Address: 349 – 357 Beamish St, Campsie

Re: Upcoming S4.56 Lodgement

From: Georges Jreije <Georges@urbanlink.com.au>
Sent: Monday, 25 July 2022 4:24 PM
To: Michel Samaha | probject
Cc: Reina Menhem | probject; Joseph Alha
Subject: RE: 349-357 Beamish Street, Campsie | BCA Letter for Modification Application

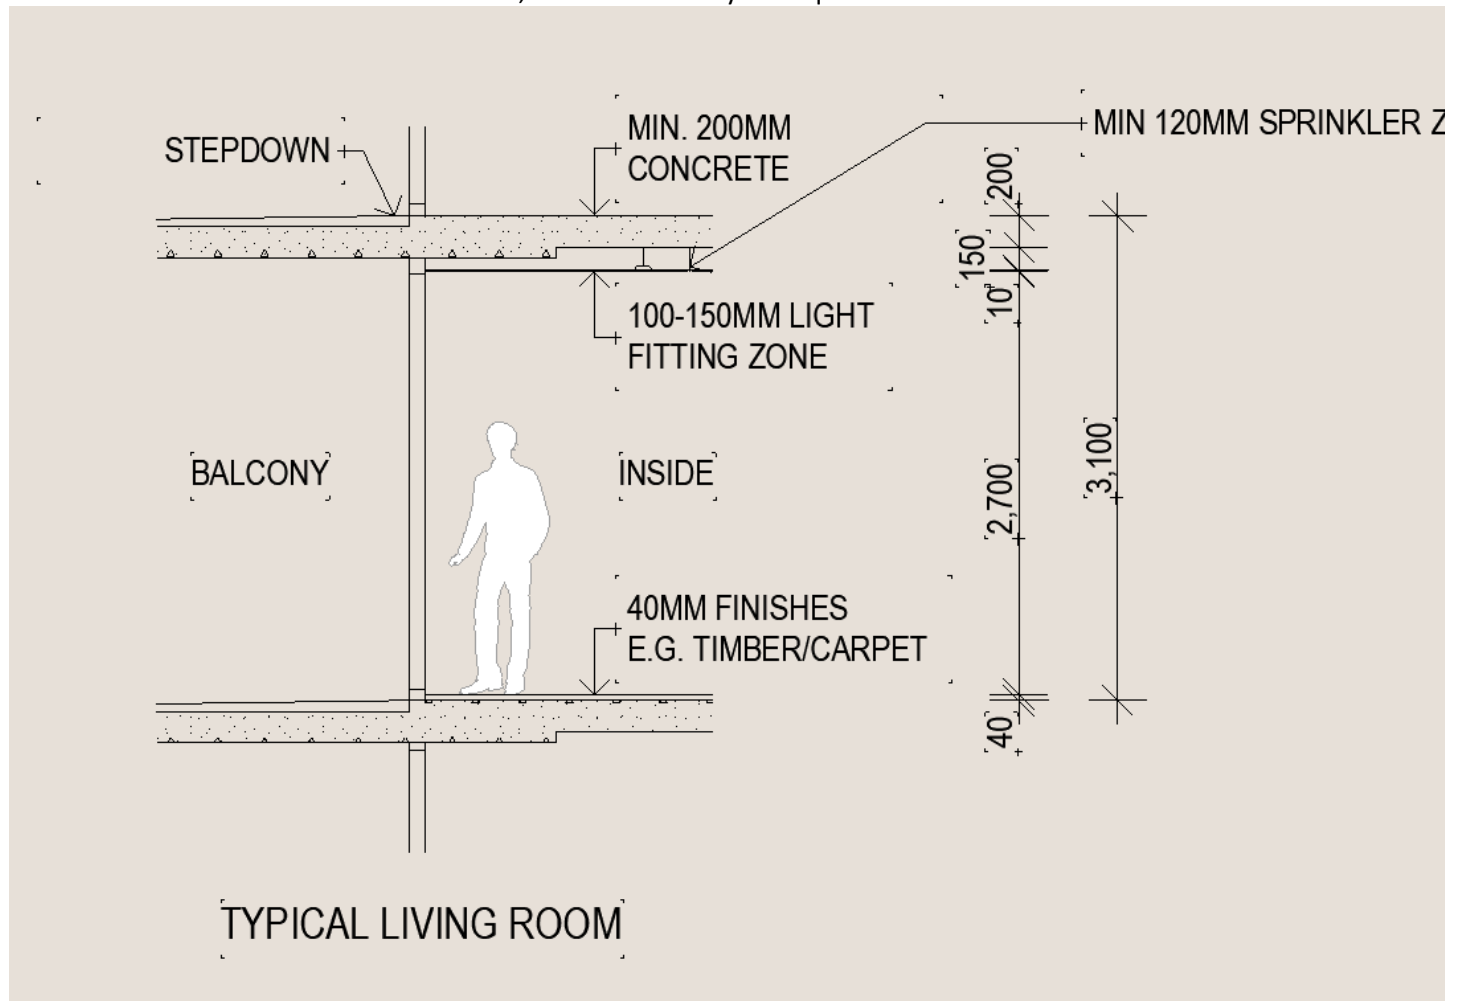
We can provide the below section showing an indication as to how the 2.7m can be achieved with a 3.1m floor to floor. Increasing the floor to floor height is required to achieve the ADG required 2.7m in habitable areas. The main change from BCA 2016 (when the application was approved) to the current BCA (2019) is the compulsory addition of Sprinklers to any building 4 storeys and over.

The below section shows the minimums required but tolerance is required as not all areas are the same. Additionally in areas where there is a transfer in structure, thicker slabs may be required.
